28F008S5

SPECIFICATION UPDATE

Release Date: February 1997

Order Number: 297796-003

A Long Series of CE# Glitches May Induce an Invalid Read

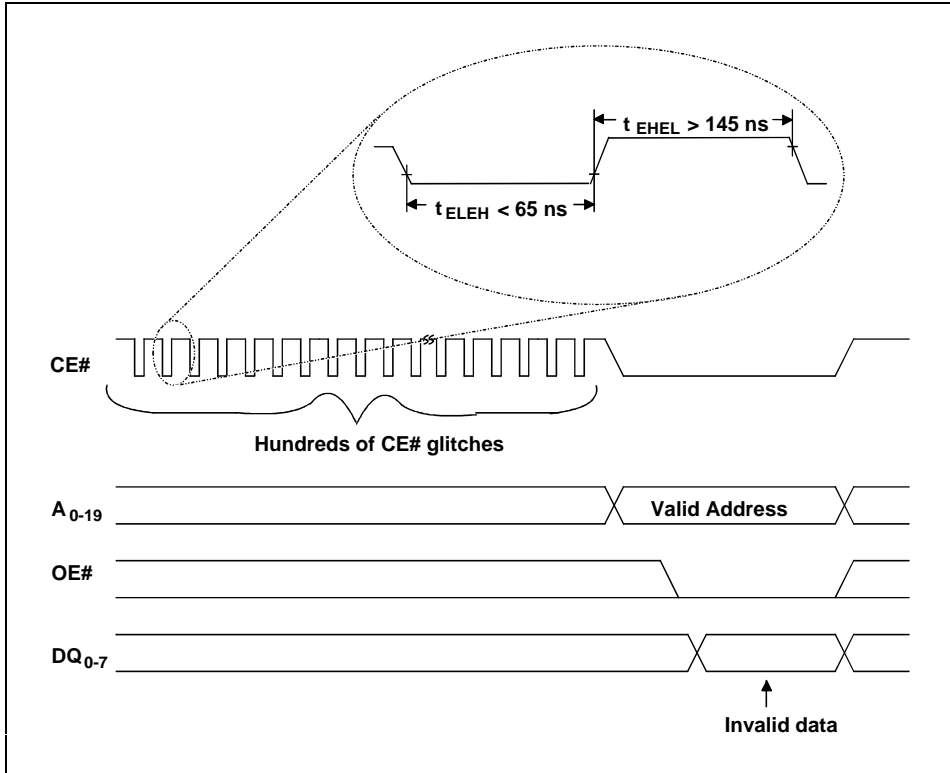
PROBLEM: A noisy CE# control signal may cause an invalid read. This erroneous read only occurs after the device has received over one hundred consecutive short CE# glitches ($t_{EHL} < 65 \text{ ns}$) with intermittent CE#-high time (t_{EHEL}) greater than 145 ns (see the figure below, *A Long Series of CE# Glitches May Induce an Invalid Read*).

After valid data is read, the device must receive another series of CE# glitches (typically over one hundred) to induce an invalid read. CE# glitches sequences, other than defined in the above figure, *A Long Series of CE# Glitches May Induce an Invalid Read*, have no adverse effect.

WORKAROUND: If it is determined that the CE# causes a problem, possible solutions to help workaround this erratum are suggested as follows:

Hardware solution:

Add system logic to prevent CE# glitches such as latched CE# control logic or pullup/pulldown resistors to the address bus.

Hold RP# Active While V_{CC} Ramps

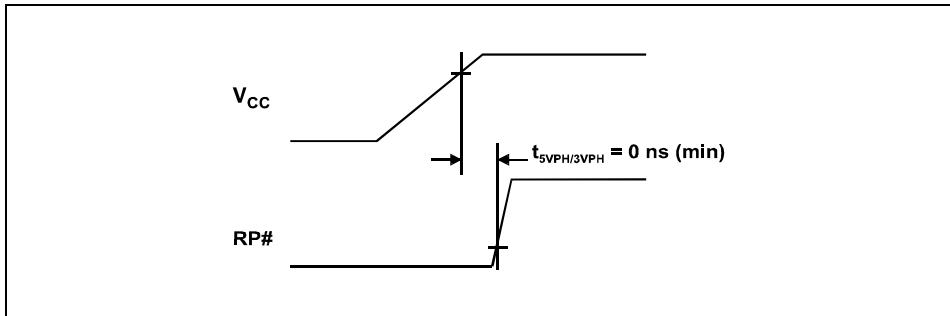
PROBLEM: RP# must be held low while V_{CC} ramps to a valid level during power transitions.

Holding RP# low during power-up blocks spurious write initiated by system control logic which may occur as the system voltage transitions to a stable level. Intel recommends the usage of RP# for CPU/memory reset synchronization, write protection, and deep power-down mode.

IMPLICATION: This erratum only affects power-up operations. Systems that tie the flash memory's RP# input to the system RESET# signal typically will not have a problem with erratum because the RESET# signal is usually held low during the power-up sequence to properly synchronize the CPU. However, systems that ties RP# directly to V_{CC} will be more exposed to this problem. So, carefully analyze RP# during the power-up condition to fully understand its behavior.

WORKAROUND: If it is determined that this erratum may cause a problem, here is a possible workaround.

Use a simple RC delay network to hold RP# low during the power-up condition or tie the RP# input to the system RESET# signal. This workaround will eliminate your exposure to this problem and also provide your design with additional power-up security.
